312 9th Avenue North

ARC #4

Date: September 30, 2022

1. ARC #3 Response
2. Recap of Proposed Alterations
3. Rec. Approved Design
4. ARC Process Summary

Alternate Harrison Entry Proposal:

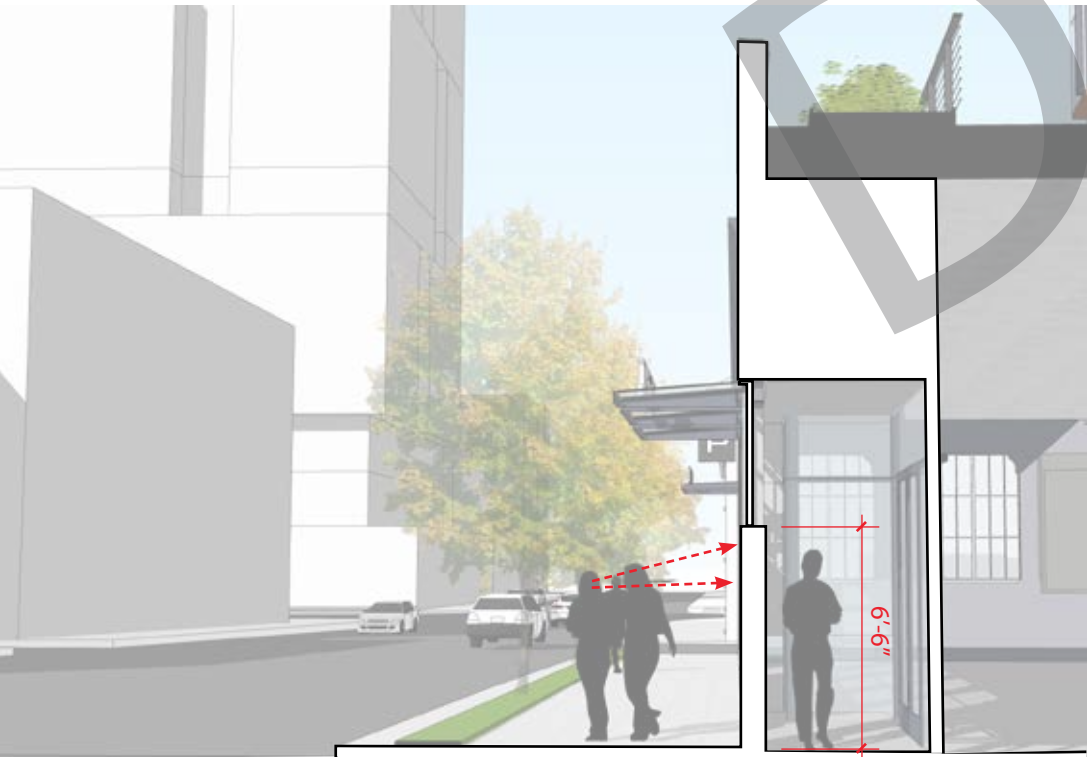
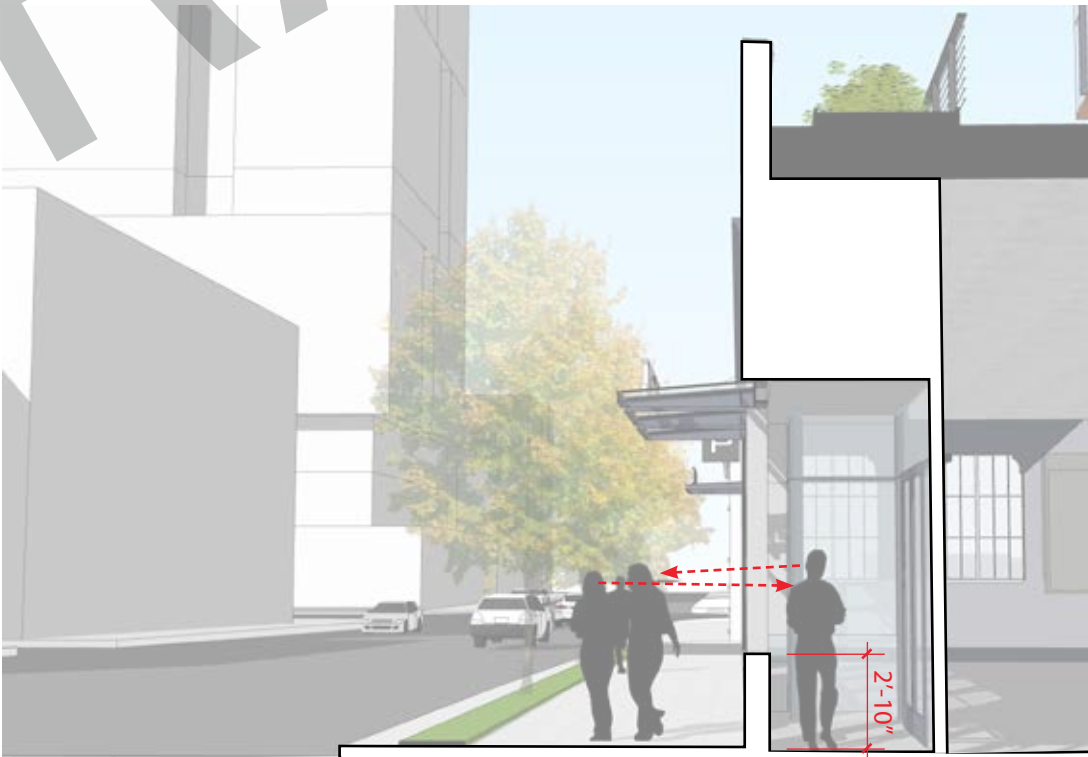
- A. Continued ARC support for the overall building design and relationship to the landmark.
- B. ARC members were pleased with level 1 window in kind replacement strategy.
- C. ARC members were pleased with level 2 glazed-in bleacher window option.
- D. Show a clearer picture of the north retail entry lowered sills at Harrison Street. Seek design review input for best strategy for visibility and safety needs according to neighborhood design guidelines.

The main Harrison Street entrance for the landmarked site includes two sill elements within the archways that are being proposed for removal.

The previous entry of the building was elevated with a few stair steps bringing the sills to an appropriate height for visibility. However, this design was not accessible. The proposed design lowers the Harrison Entry to grade level and provides a recess wide enough for ADA access. By maintaining the existing sills as currently constructed, the recessed vestibule will create a blind spot that allows people to hide within the space and create a safety concern.

In order to maintain a safe, vibrant storefront environment, the preferred option proposed is wishing to remove these sills and improve the building's design to ensure more longevity and provide pedestrian comfort for the public.

These alternative approaches were presented at Design Review on July 6, 2022 and **board preference was stated for the "preferred option" of lower sills for visibility, safety, and street level interaction**

Proposal at Rec 1:

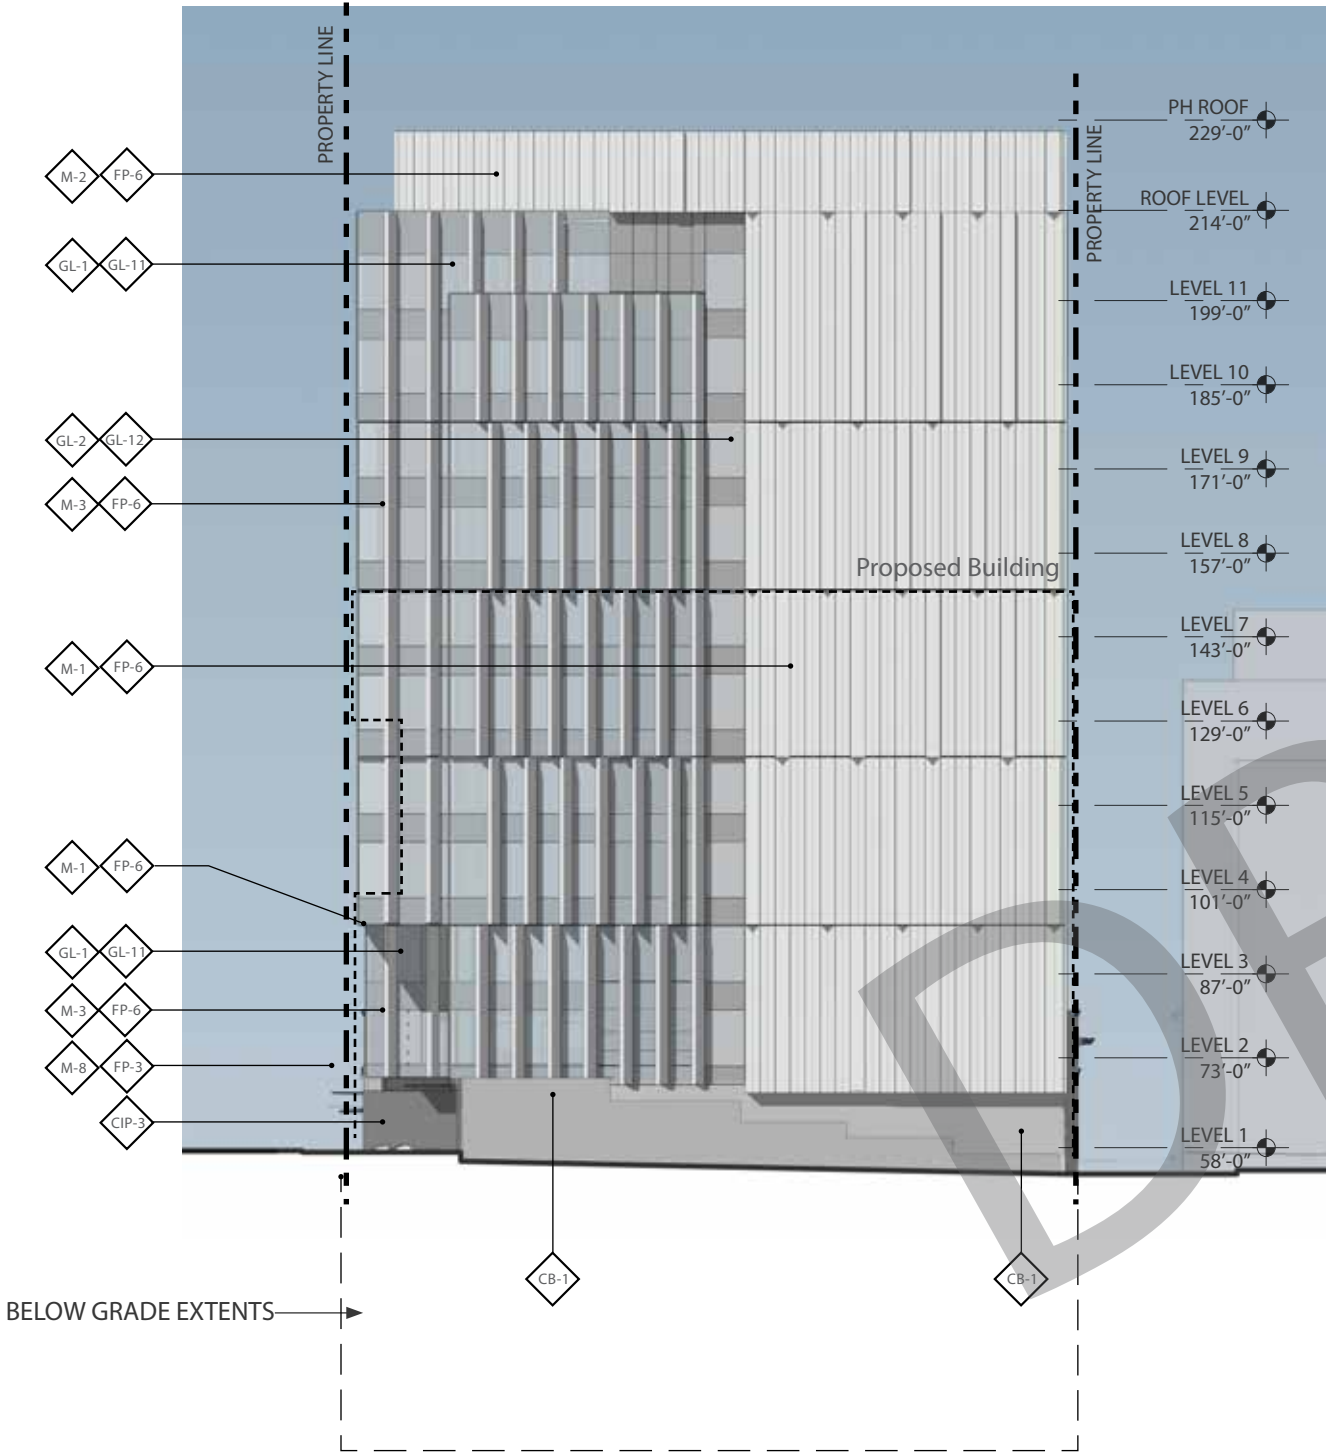
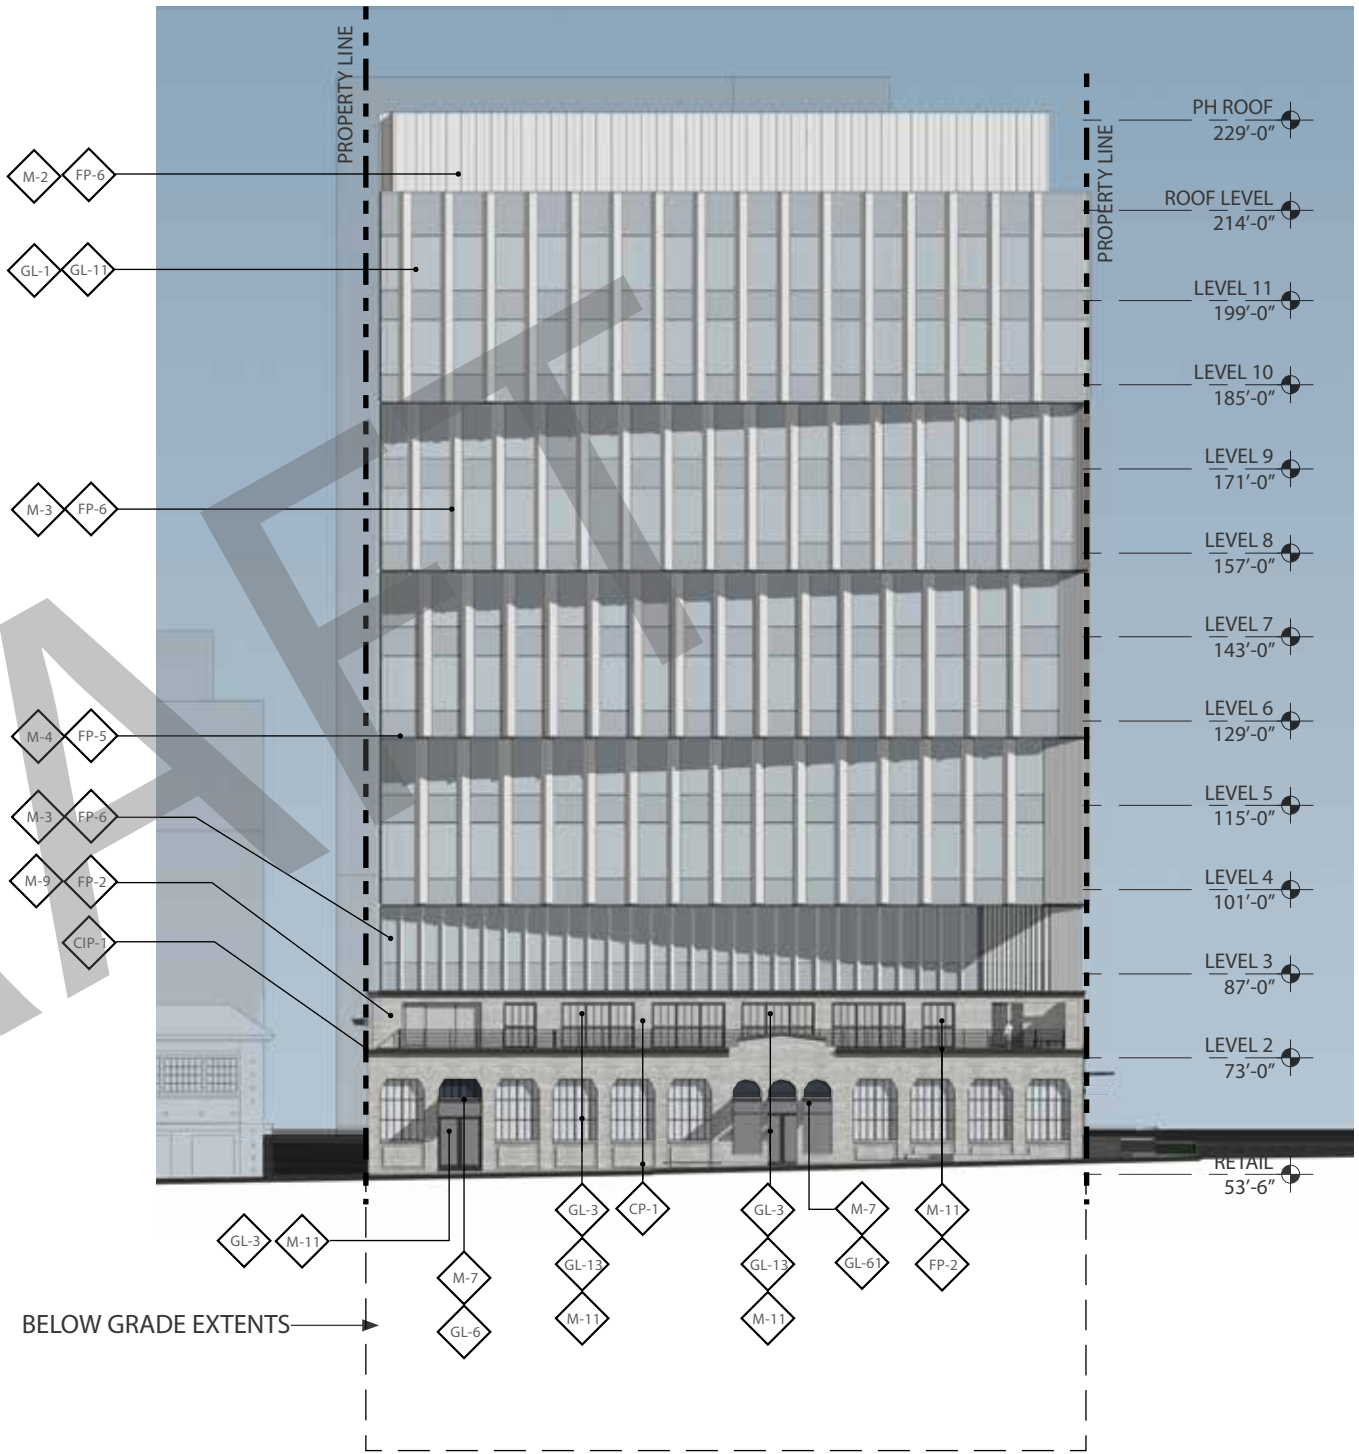
The project had its first Design Review Board (DRB) Recommendation meeting on March 9, 2022. The DRB requested some modifications to the building, and the project was approved at the second Recommendation meeting on July 20, 2022. The modifications to the landmark building have not substantively changed since the last ARC meeting on February 11, 2022. The main purpose of this meeting is to share the updated design with the ARC and finalize the changes proposed heading into the Landmarks Briefing Meeting in October.
